**Planning Department
Transportation Development Services**

Re: Advanced Auto Parts
2801 4th St., NW
Traffic Circulation Layout
Engineer's/Architect's Stamp dated 8-1-15 (H14-D041)

Based upon the information provided in your submittal received 9-17-15, the above referenced plan cannot be approved for Building Permit until the following comments are addressed:

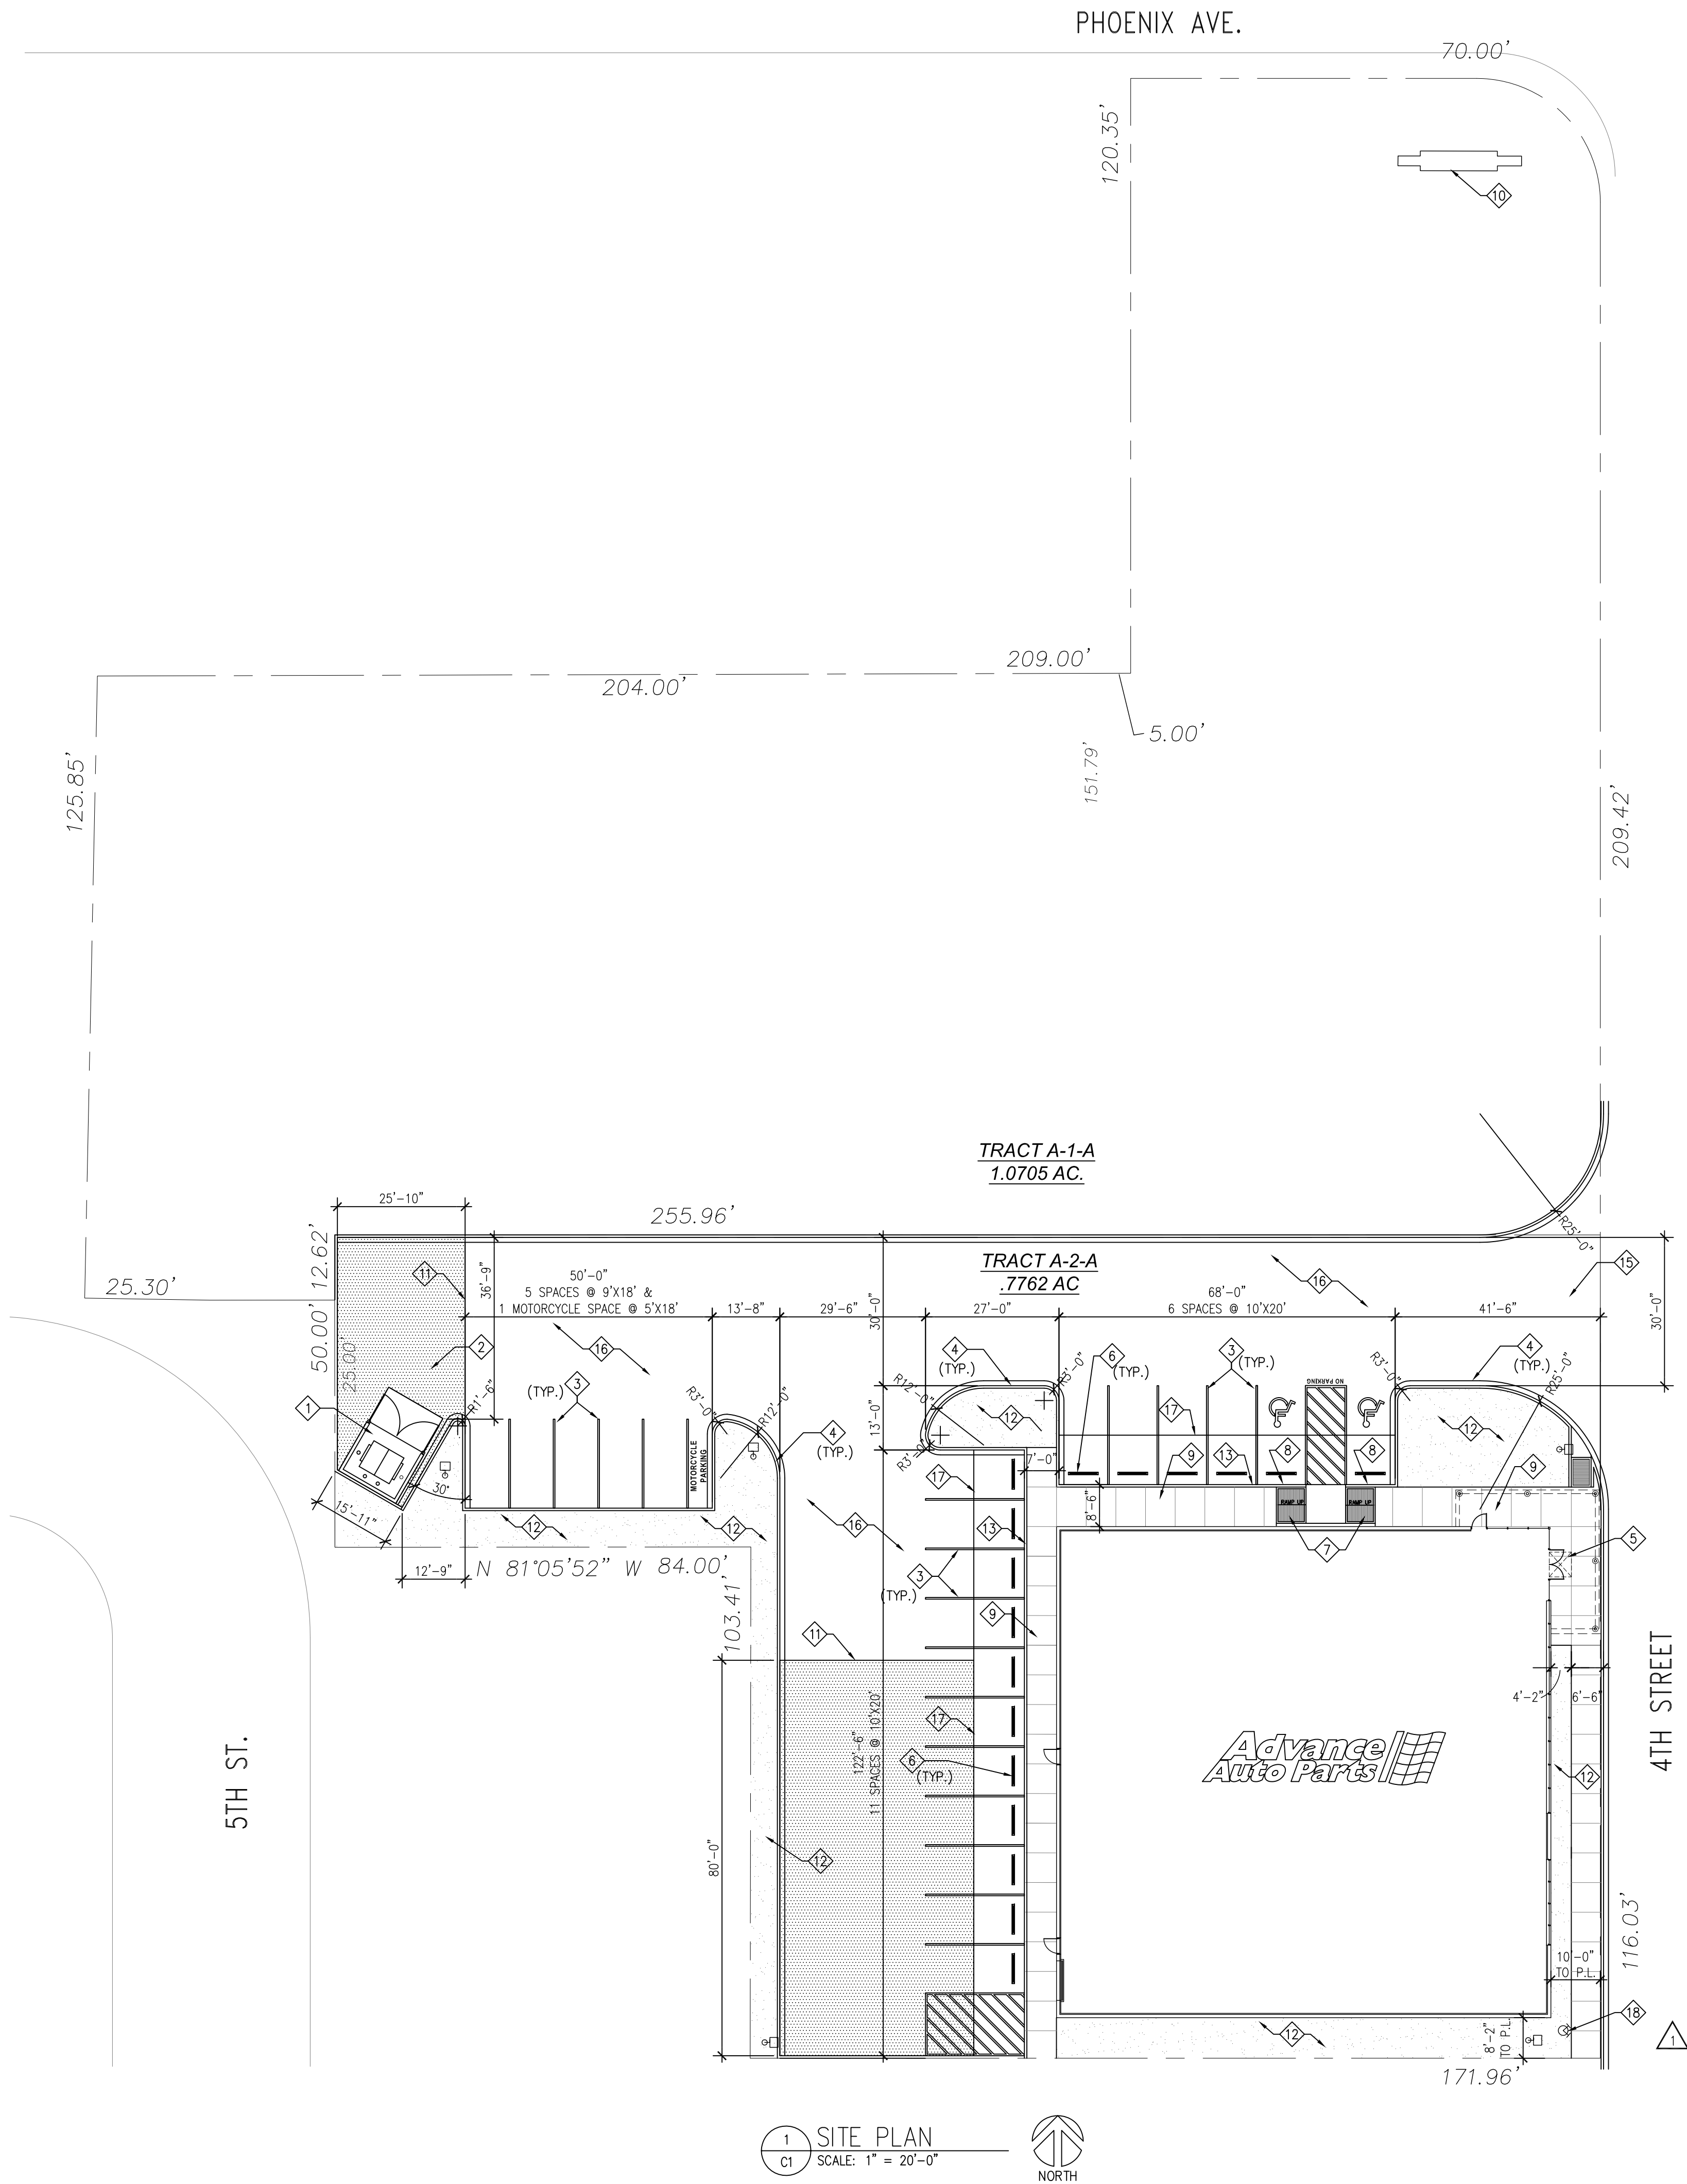
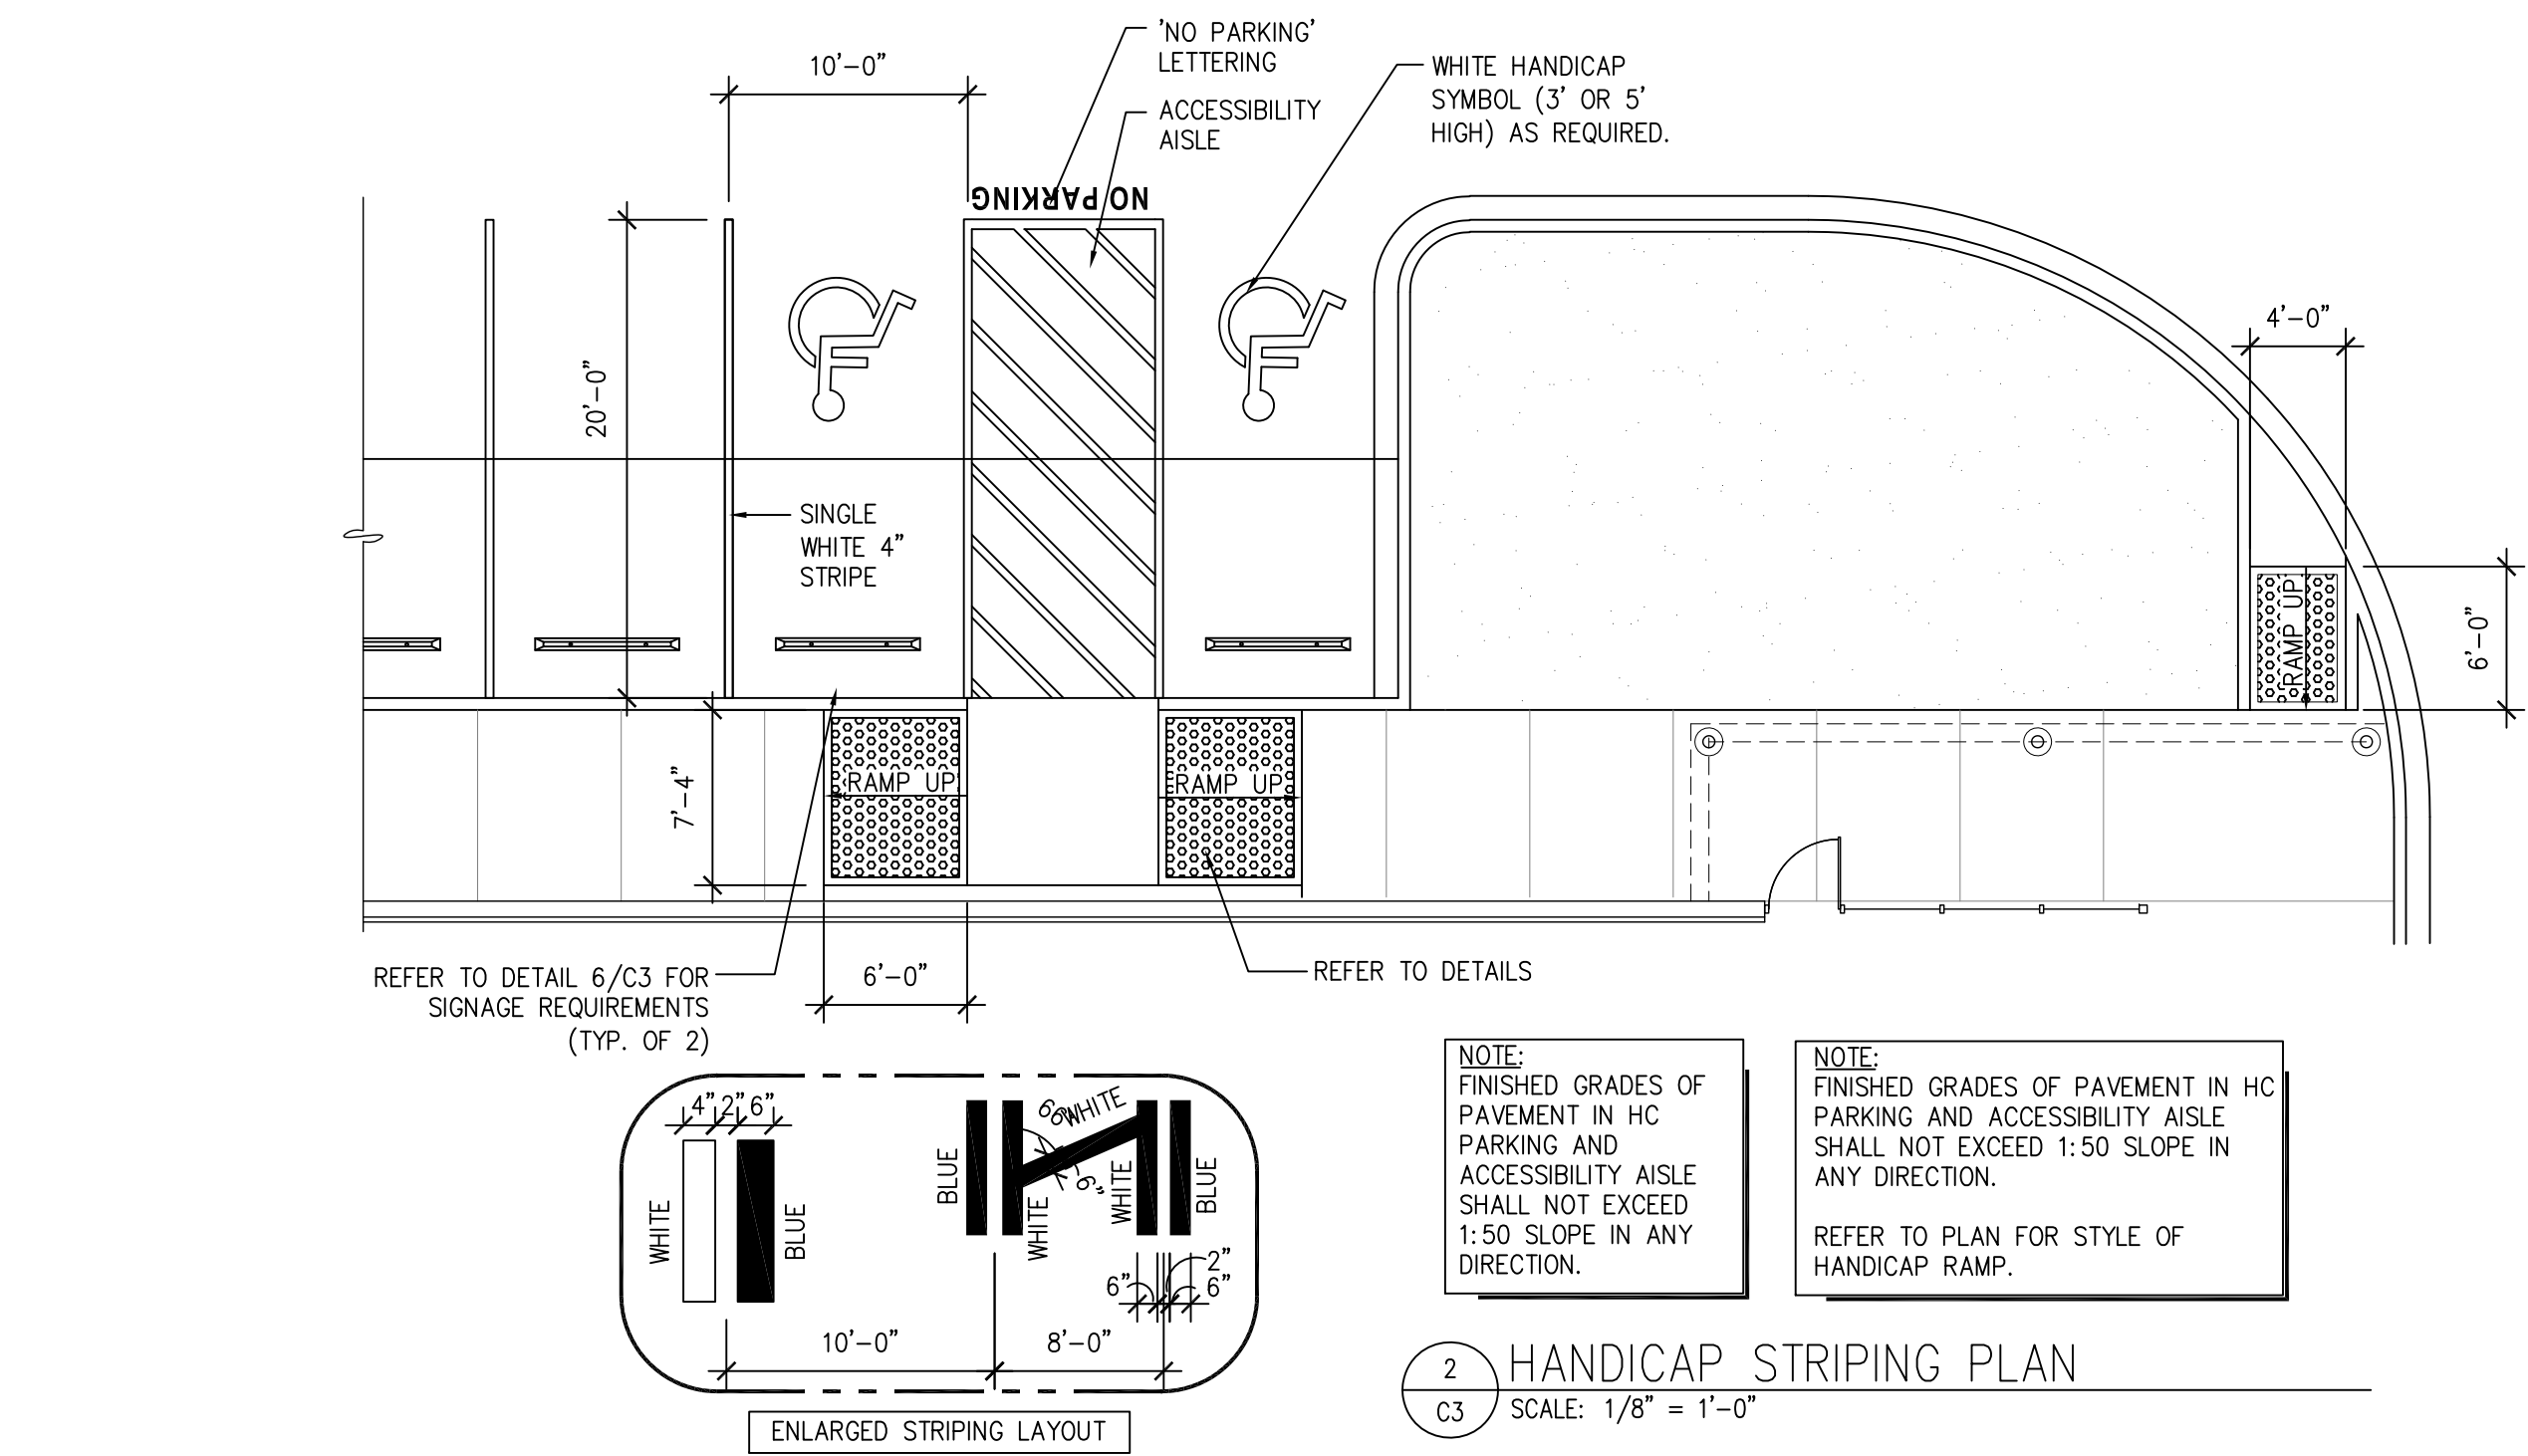
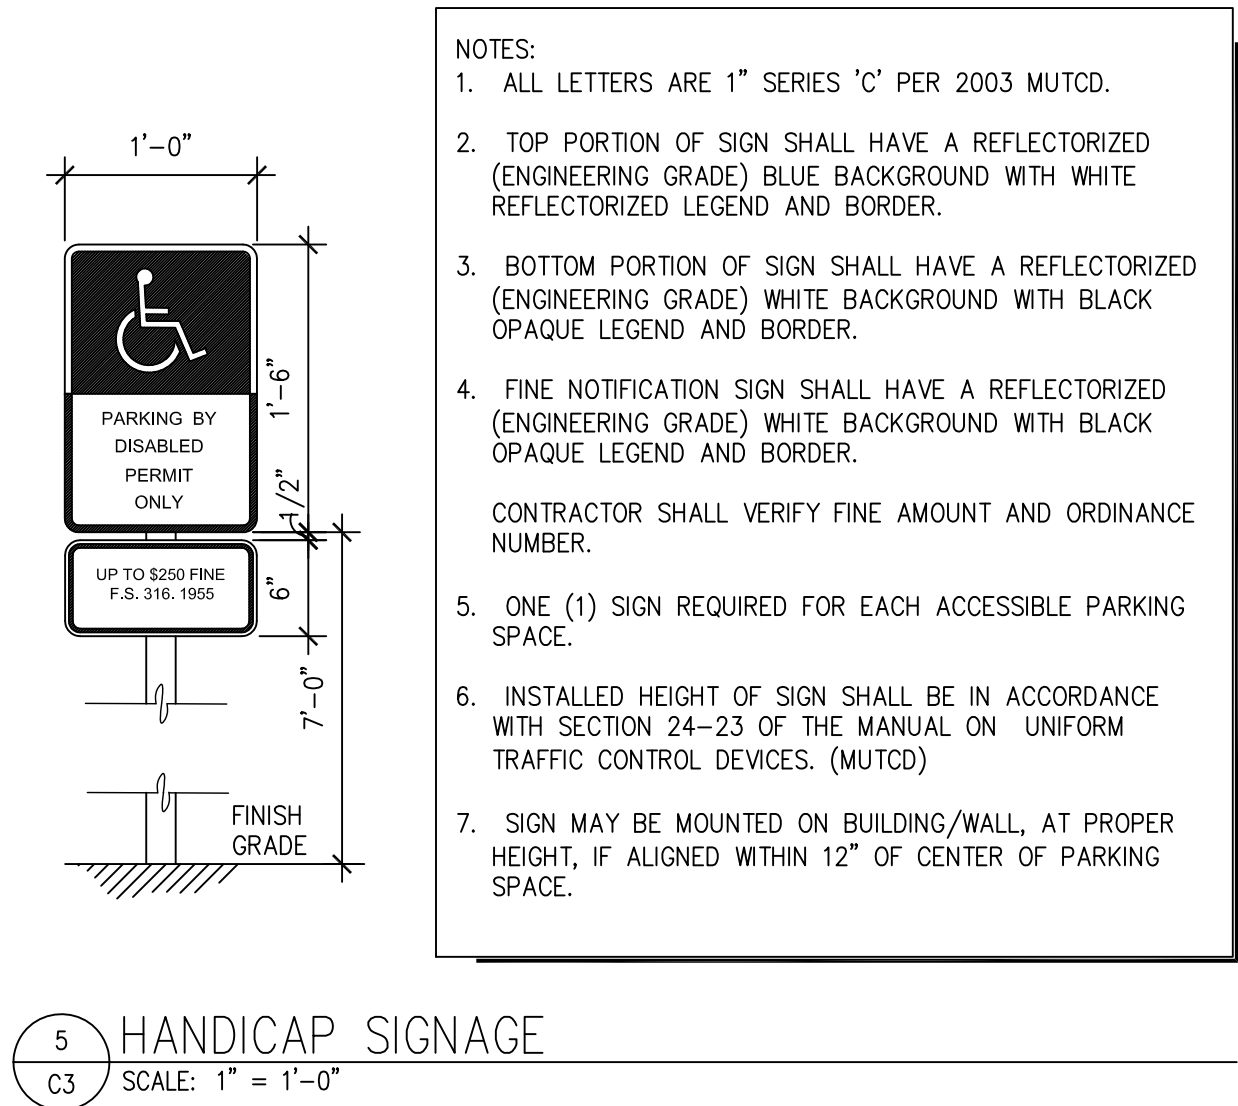
1. Clarify the extents of the current phase. Please detail or state if there is an existing building and if it is to be demolished.
2. Identify all existing access easements and rights of way with dimensions. Please clearly show right of way side walk and pedestrian pathways on 4th st.
3. Identify the right of way width, medians, curb cuts, and street widths on both 4th St. and Phoenix Ave.
4. Service vehicle and/or refuse vehicle maneuvering must be contained on-site; provide a copy of refuse approval.
5. Please provide a sight distance exhibit (see the *Development Process Manual, Chapter 23, Section 3, Part D.5 Intersection Sight Distance*). Please provide this detail for entrance on 4th St.

6. Please add the following note to the clear sight triangle: "Landscaping and signage will not interfere with clear sight requirements. Therefore, signs, walls, trees, and shrubbery between 3 and 8 feet tall (as measured from the gutter pan) will not be acceptable in this area."
7. Unused curb cuts must be replaced with sidewalk and curb & gutter. They must be shown and a build note must be provided referring to the appropriate City Standard drawing.
8. Please include two copies of the traffic circulation layout at the next submittal.
